TENDER ADDENDUM

Project: UHN Interventional Fluoroscopy Tender Addendum #:

University Hospital of Northern British Columbia

The following information supplements and/or supersedes the "Issued for Tender" drawings issued for the above project dated February 10, 2021.

Summary Table - MINIMUM Shielding

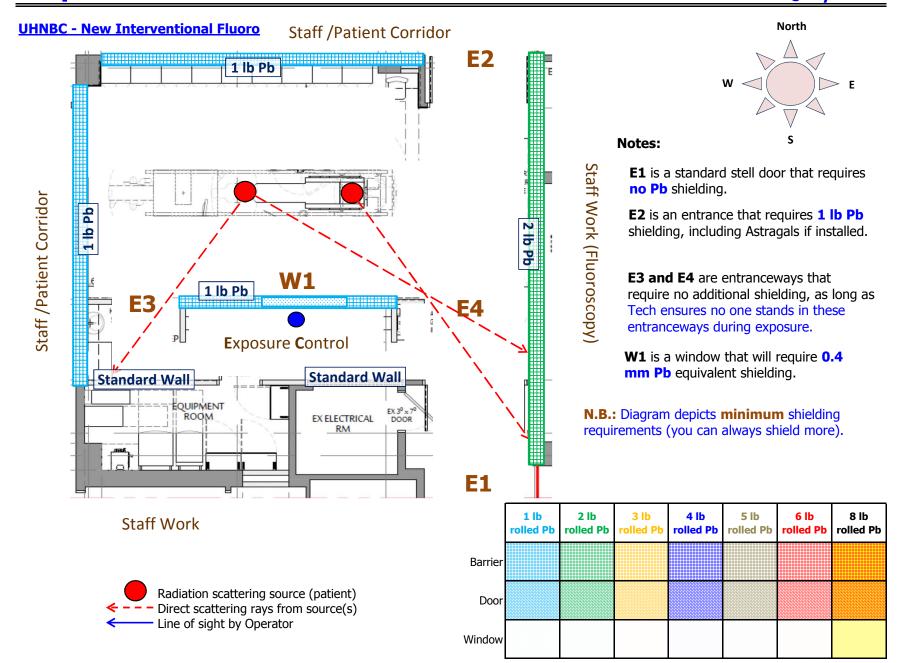
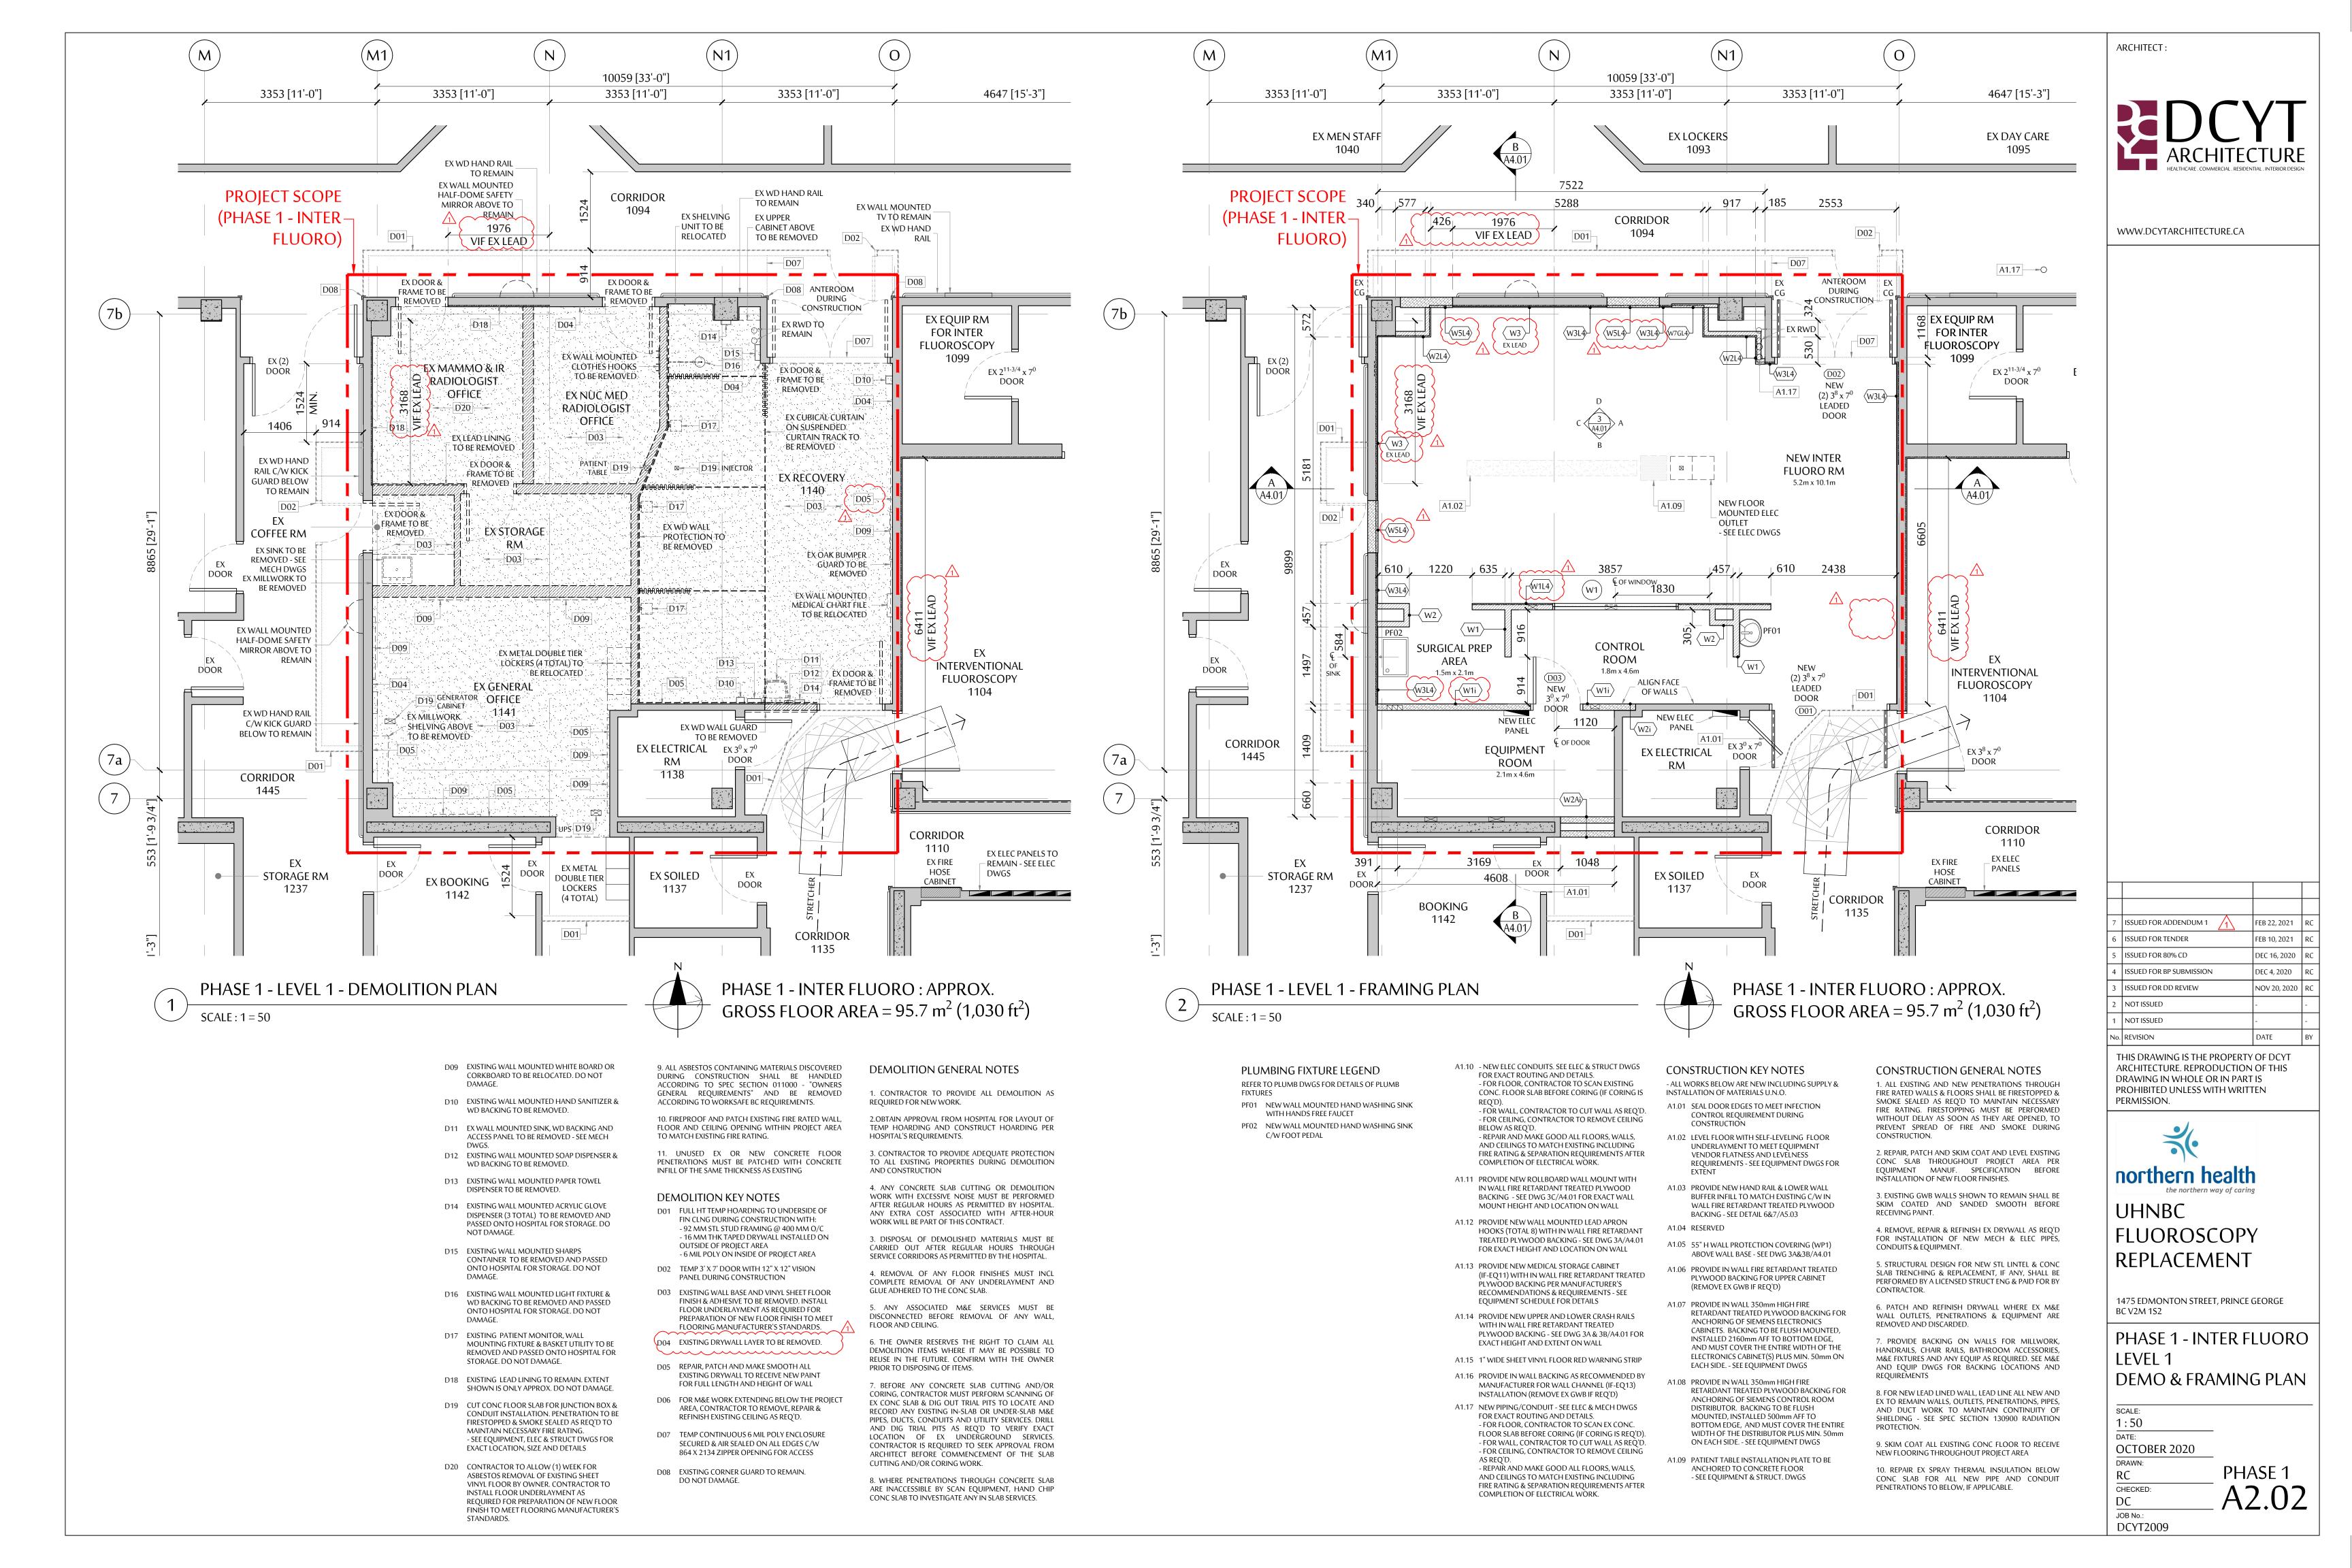
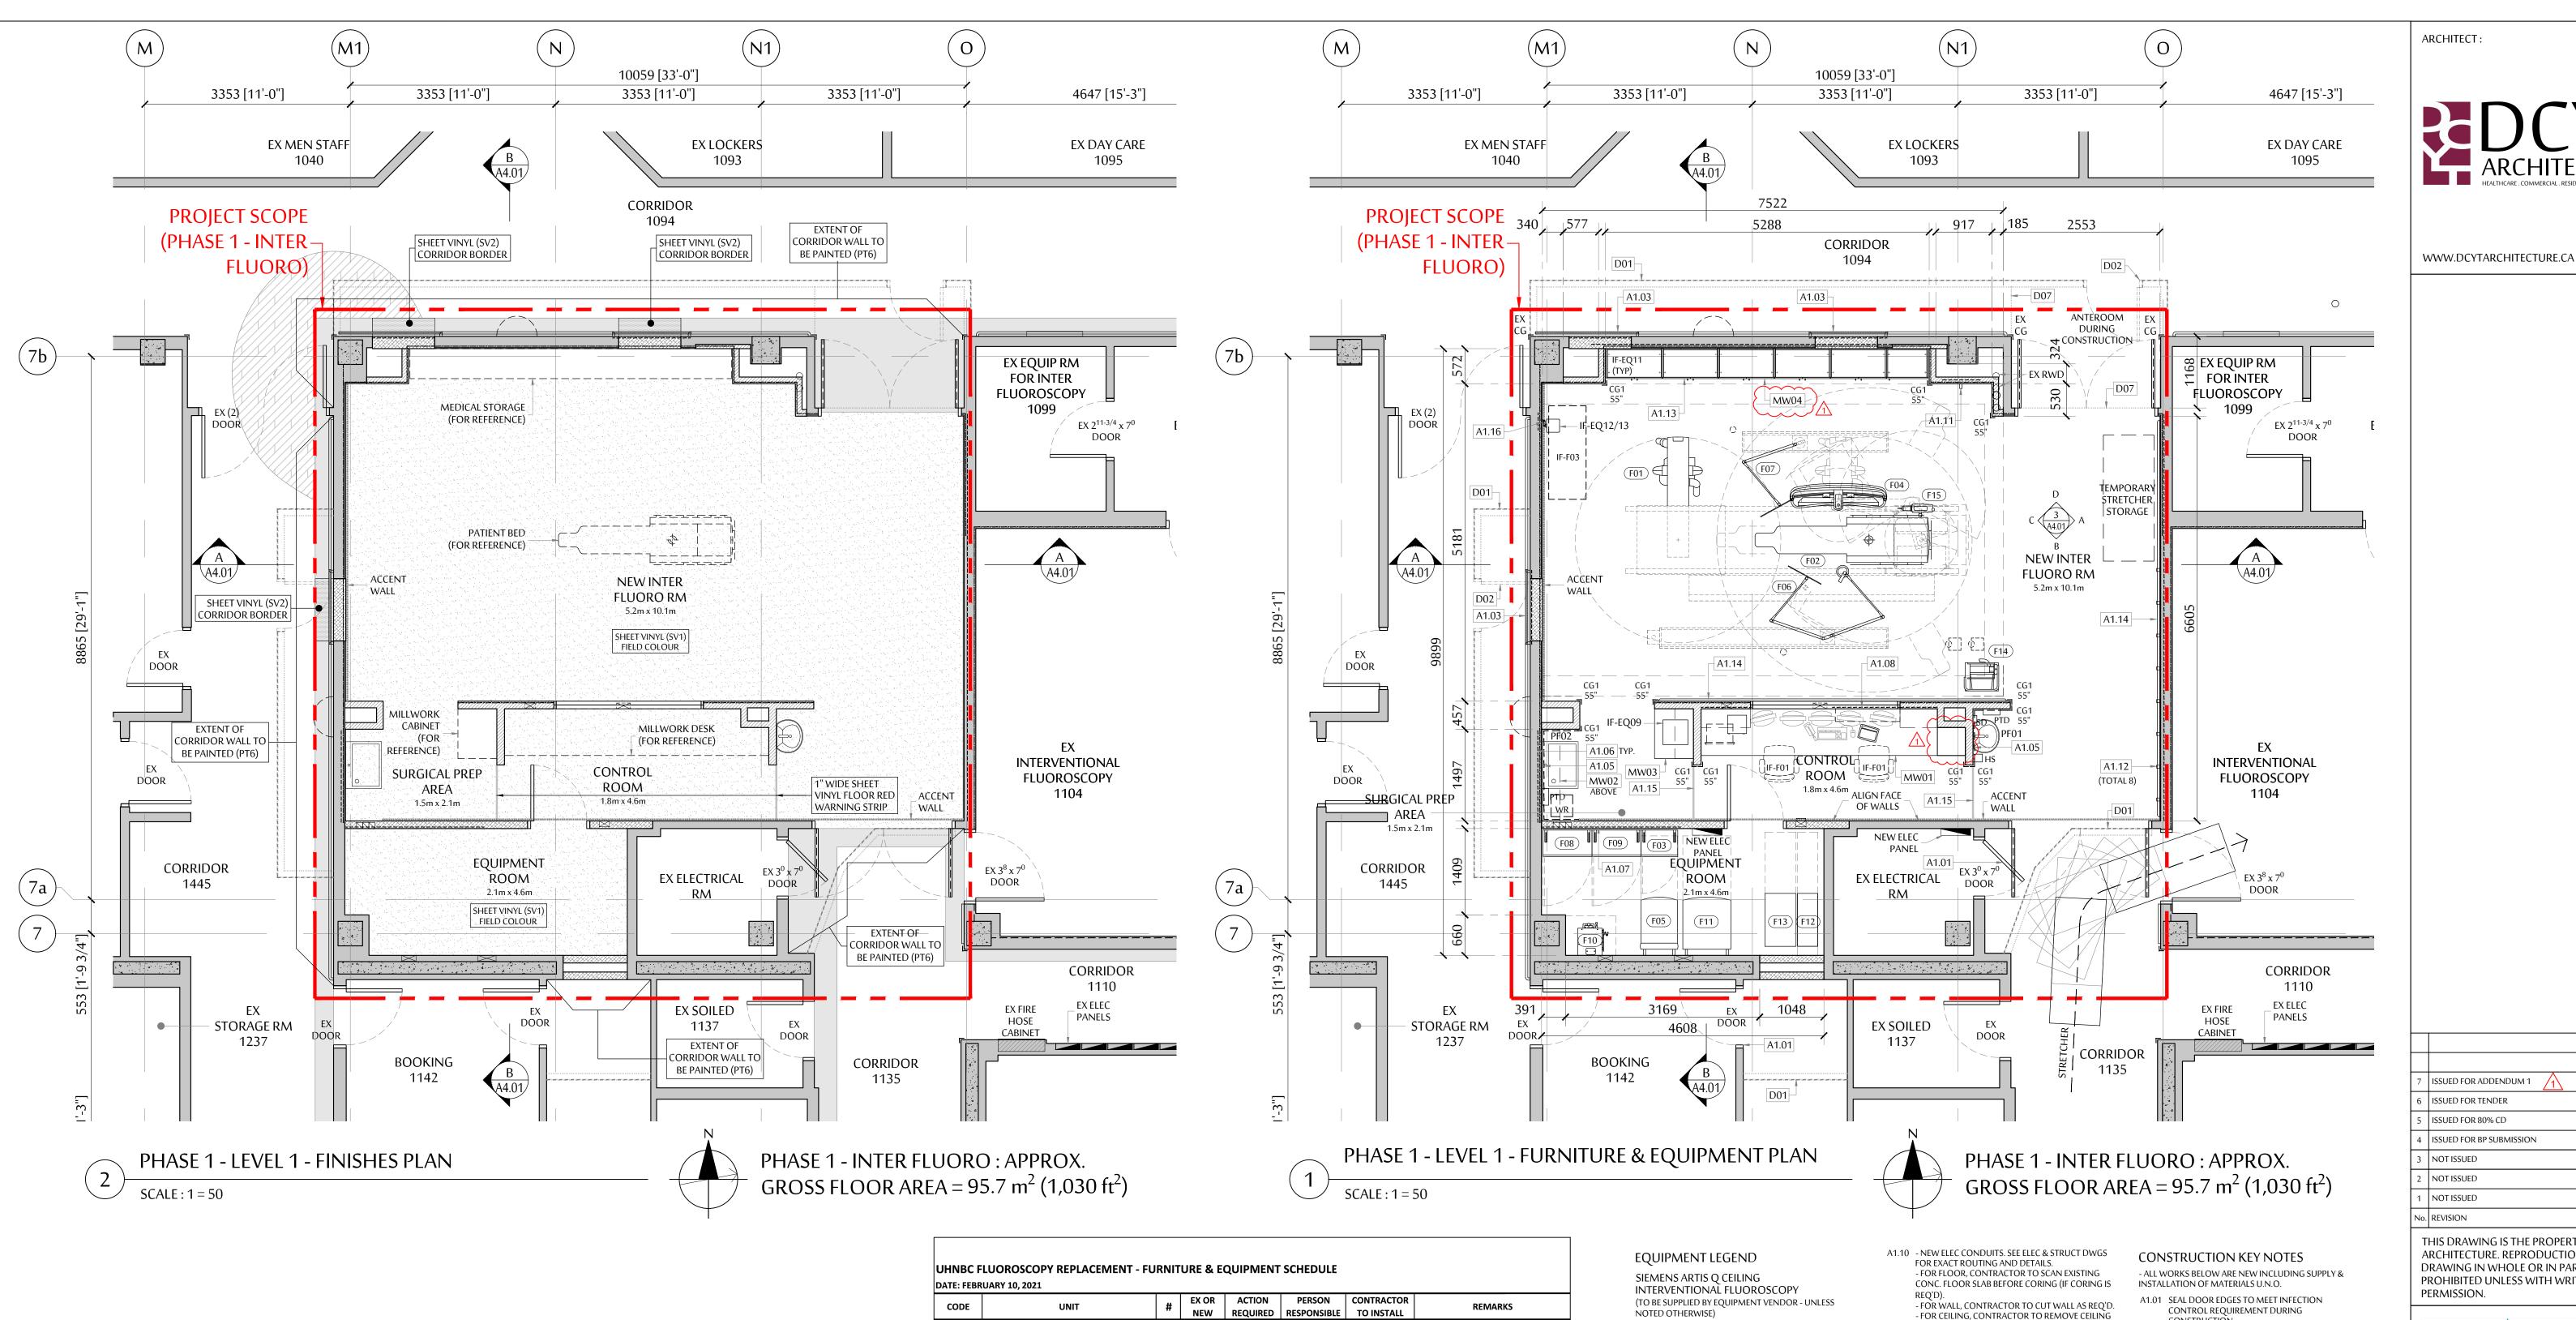
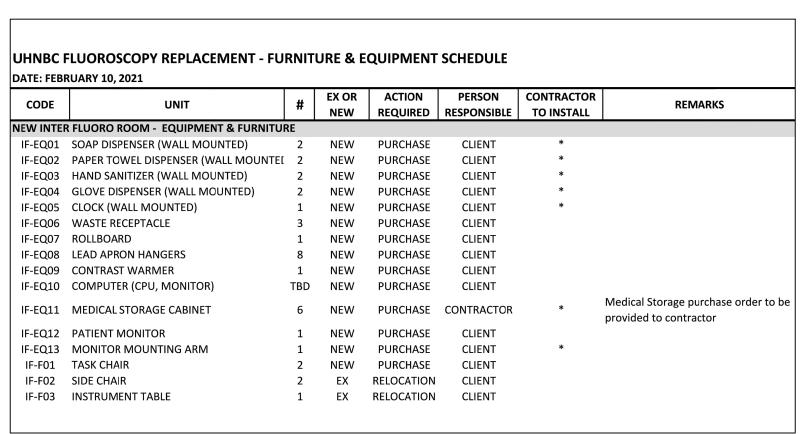
The shielding requirements for your New Interventional Fluoro are noted on the charts and drawings on the following pages. These requirements incorporate distances, occupancy levels of the adjacent rooms and spaces, maximum x-ray tube potential, exam workloads, and any other variables as provided and noted.

Where a barrier encompasses an entrance (designated E1, E2, etc. on the drawing), the entrance will require a door with the same shielding capabilities as the surrounding barrier.

Where a barrier encompasses a window (designated W1, W2, etc. on the drawing) which is typically used to separate the exposure control position from the exam room, then the window will need to be constructed of Pb-glass or sufficient plate glass, with the same shielding capabilities as the surrounding barrier.

For all barriers/walls, the shielding needs to extend from the floor to a height of 2.17 meters (7 feet) above the floor for each barrier (including the door).
